LTR-NRC-10-63

Subject: Westinghouse Comments to NRC on DSS-ISG-2010-01, "Staff Guidance Regarding the Nuclear Criticality Safety Analysis for Spent Fuel Pools", Docket ID NRC-2010-0289.

**Westinghouse Comments to NRC on DRAFT Interim Staff Guidance
DSS-ISG-2010-01**

Figure 1: Representative Reactivity Effect of Burnable Absorbers

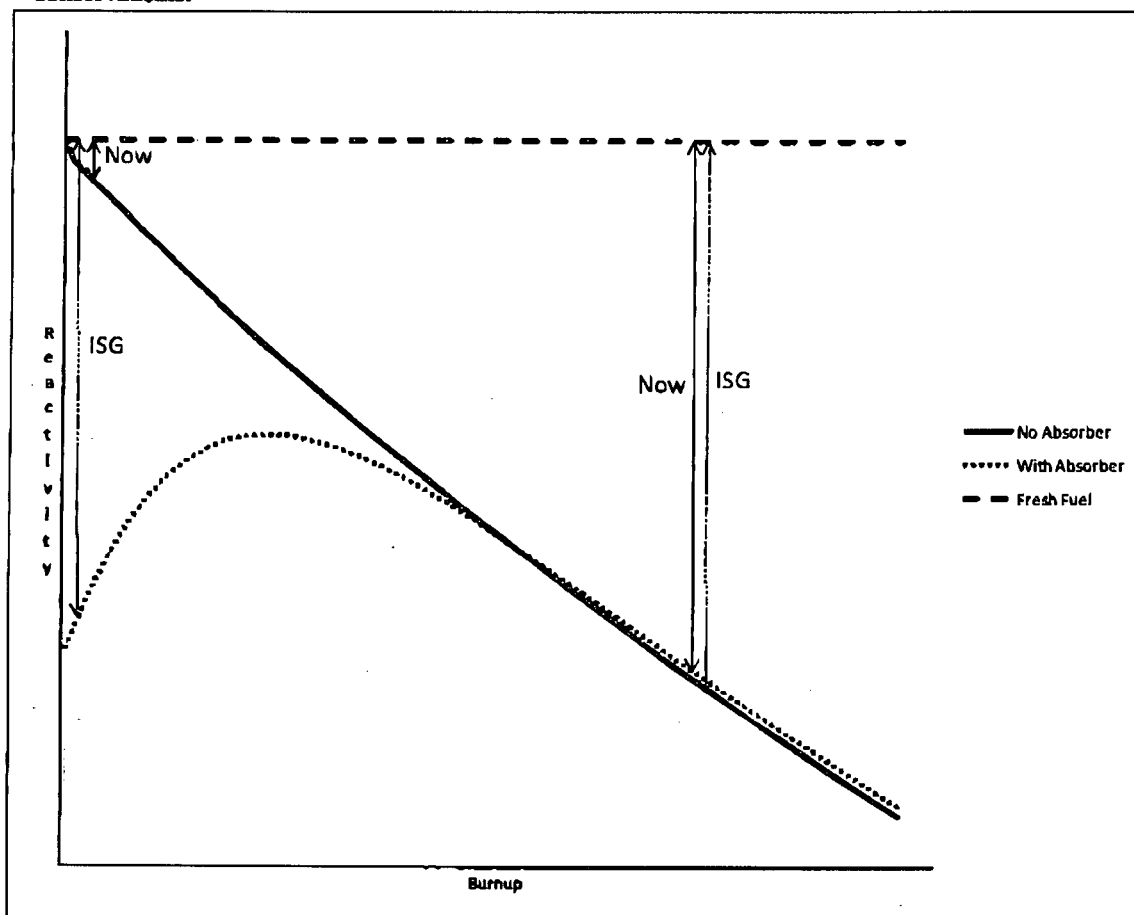
Section 2.a.ii: Remove the requirement "with or without residual neutron absorber". This recommendation would require an inconsistent application of conservatism in two cases.

Issue 1: The first inconsistency impacts the application of the depletion uncertainty at low burnups with burnable neutron absorbers (IFBA, Gd, Erbium, WABA, BPRA, Pyrex, etc). As shown on the left side in Figure 1, the difference in reactivity between an assembly that contains burnable absorbers versus an assembly that does not contain burnable absorbers is significant at low burnups. Applying 5% of the reactivity difference between the fresh assembly and the assembly with burnable absorbers would suggest that a significant conservative uncertainty be applied even in the case where the residual neutron absorber is not credited in the low burnup assembly. This would also create a large discontinuity in the maximum k_{eff} (which includes all biases and uncertainties) between the fresh fuel assembly where integral absorber is not credited in the spent fuel pool and the slightly burned fuel assembly, where the large "depletion uncertainty" would be applied according to the prescription in the draft ISG. Neglecting the residual burnable absorber is a much more significant conservatism than applying the 5% depletion uncertainty and therefore it is not necessary to apply both of these conservatisms.

Issue 2: The guidance as written would recommend a double application of conservatism from two separate configurations. To illustrate this point, Figure 1 shows the reactivity of two fuel assemblies in

a representative spent fuel storage rack as a function of burnup. The first assembly (dotted line) includes burnable absorbers, while the second assembly (solid line) is identical to the first, only without the burnable absorber. The reactivity of the fresh fuel assembly is also shown as the horizontal (dashed) line. If the draft guidance were followed verbatim, the depletion uncertainty would have to be calculated based on the difference in reactivity of the fresh fuel assembly and the assembly that contained no neutron absorber, because it has the lower reactivity at higher burnups as shown in the left of Figure 1. However, as required by Section 2.c, burnable absorbers must be considered in their effect of hardening the spectrum and providing a more reactive fuel assembly at the same burnup and enrichment. The NRC has specified in the draft ISG the application of conservatism from two different configurations; the depletion uncertainty from the assembly with no burnable absorbers and the burnable absorber bias from the assembly that does contain burnable absorbers. Table 1 below shows a representation of the burnable absorber bias and depletion uncertainty for assemblies with and without burnable absorbers. Recent analyses have been approved by the NRC with the depletion uncertainty and burnable absorber bias applied from the assembly with integral absorbers. This statement in the ISG essentially requires that the difference in reactivity between a fuel assembly with and without burnable absorbers to be applied as both a bias *and* an uncertainty as shown in Table 1.
